CASE NO. FP-2026-0007

**ORDER OF CONDITIONAL
APPROVAL OF FINAL PLAT**

SUBJECT: Dayspring Subdivision No. 3
FP-2026-0007

Final plat consisting of 57 buildable lots and 8 common lots on 17.36 acres of land in the R-4 and R-8 zoning districts for the third phase of Dayspring Subdivision.

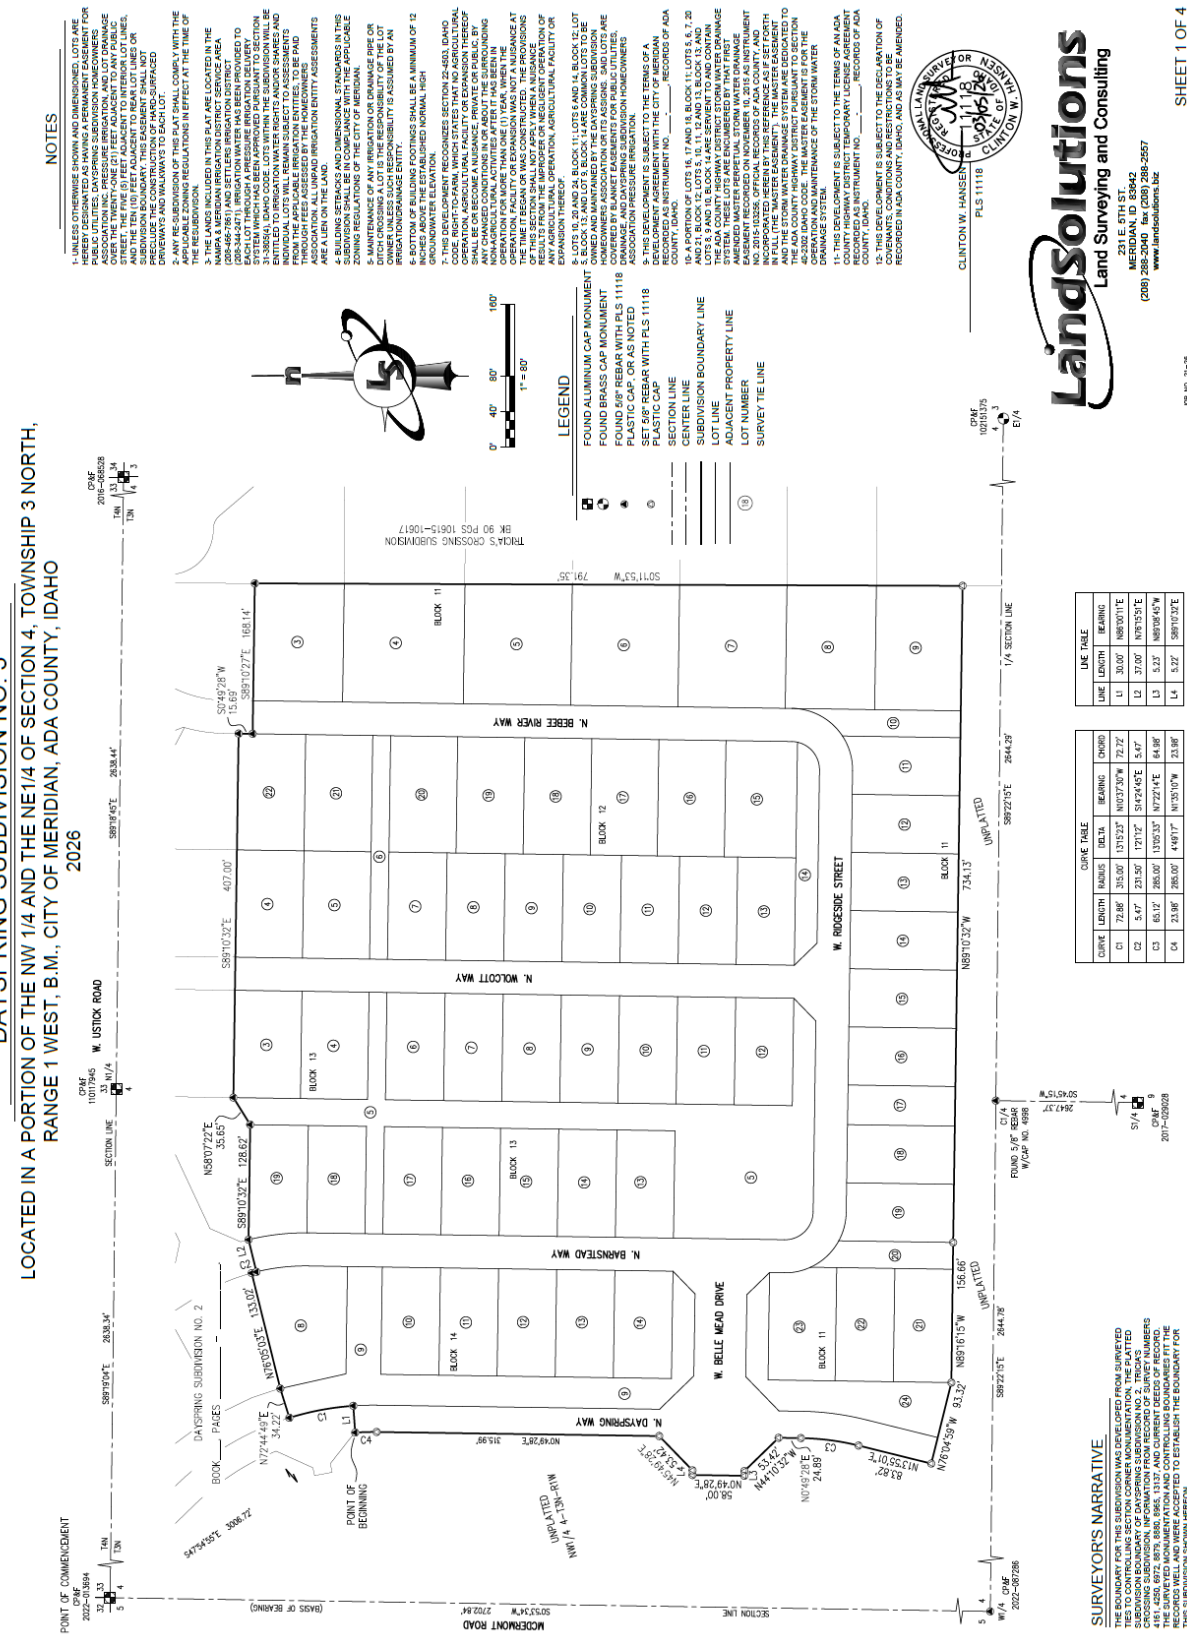
3. Prior to submittal for the City Engineer's signature, have the Certificate of Owners and the accompanying acknowledgement signed and notarized.
4. The final plat prepared by Clinton W. Hansen, Land Solutions Land Surveying and Consulting, dated: 3/5/2026, included in Section V.B shall be revised as follows:

- i. Include the Book and Page numbers for Dayspring Subdivision No. 2.
 - ii. Legend: Include the recorded instrument number of the ACHD permanent easement.

- iii. Include the recorded instrument number of the ACHD drainage easement.
 - iv. Include the recorded instrument number of the City of Meridian sewer easement.

- v. Note #9: Include the recorded instrument number for the development agreement (i.e. #2026-007562).
 - vi. Note #11: Include the recorded instrument number of the ACHD temporary license agreement.

A copy of the revised plat shall be submitted with the final plat mylar signature application.

C. Landscape Plan (dated: 2/27/2026)

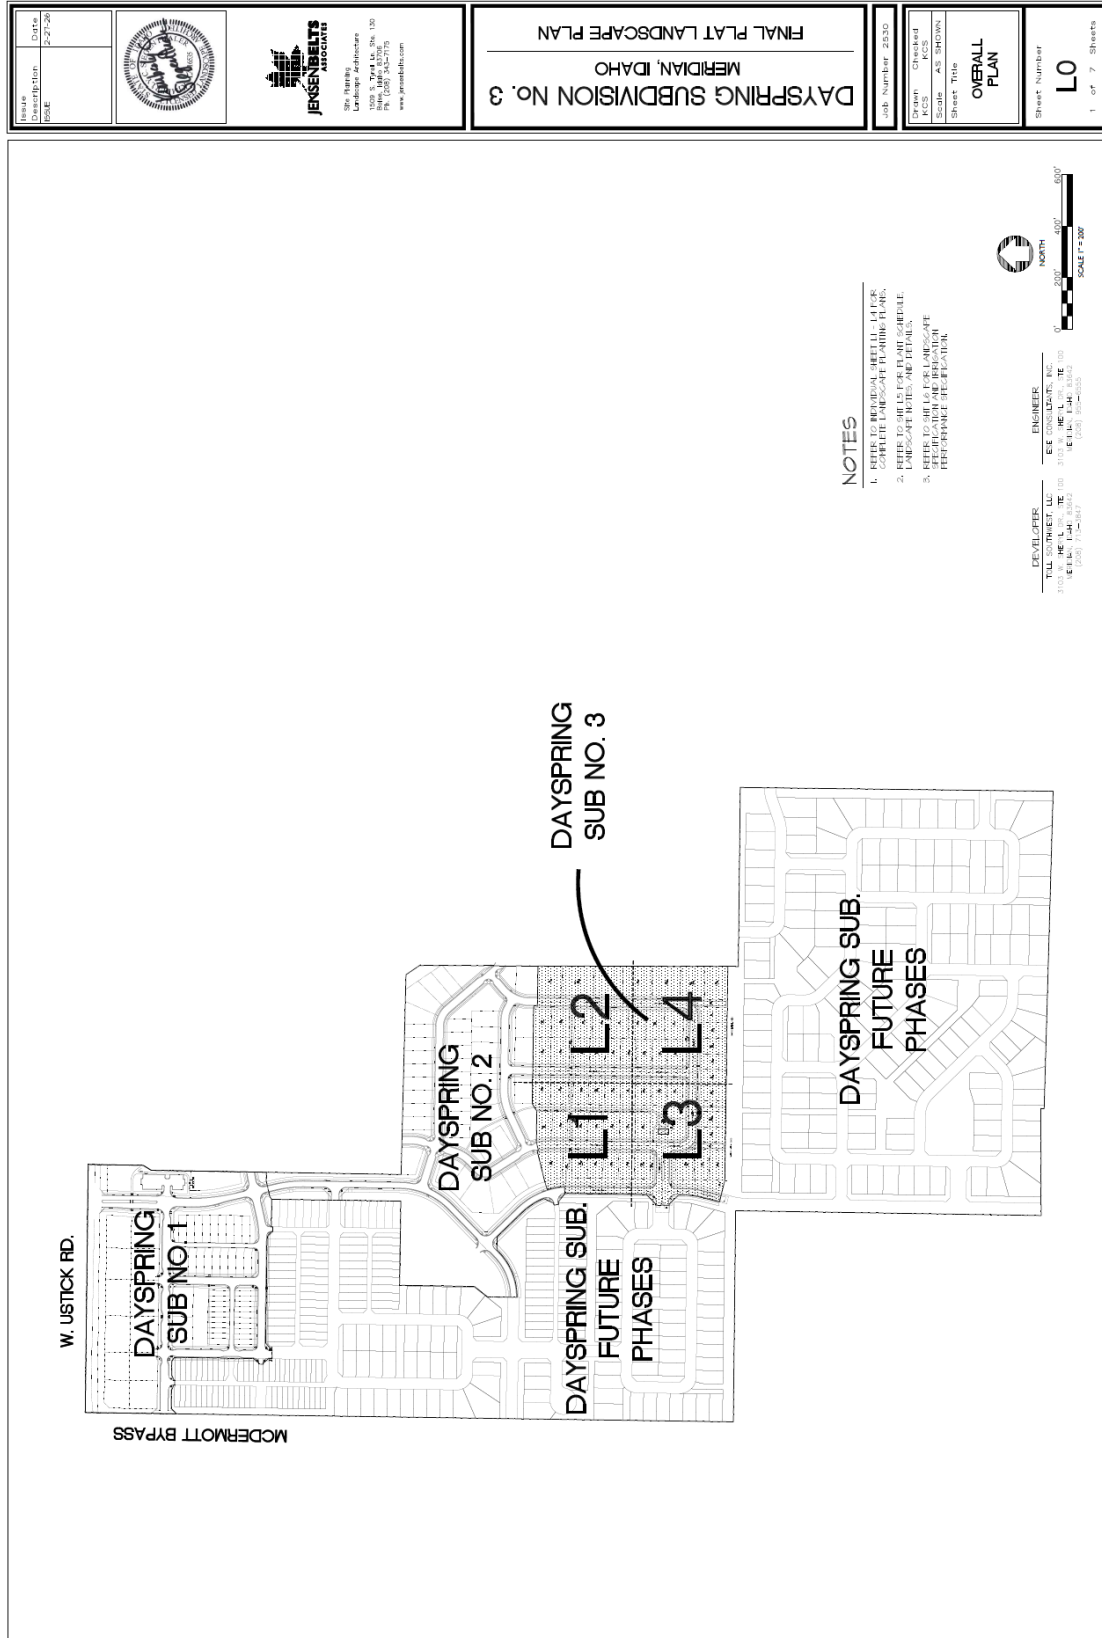
5. The landscape plan prepared by Jensen Belts Associates, dated 2/27/2026, included in Section V.C, shall be revised as follows:
 - i. Depict minimum 5-foot wide landscape strips along each side of all pathways with landscaping per the standards in UDC 11-3B-12C, which require a *mix* of trees, shrubs, lawn and/or other vegetative groundcover.

- ii. Include the required vs. proposed number of trees in common open space areas in the Landscape Calculations table that demonstrate compliance with the standards listed in UDC 11-3G-5B.3.

- iii. Include the required vs. proposed number of street trees, tree classification, percentage of lawn, and width of required (i.e. 20') vs. provided street buffer in the Landscape Calculations table for the street buffer along N. Dayspring Way that demonstrates compliance with the standards listed in UDC 11-3B-7C.3.

- iv. Include the required vs. proposed number of trees along pathways, including linear feet of pathways, in the Landscape Calculations table that demonstrates compliance with the standards listed in UDC 11-3B-12C.

A copy of the revised landscape plan shall be submitted with the final plat mylar signature application.
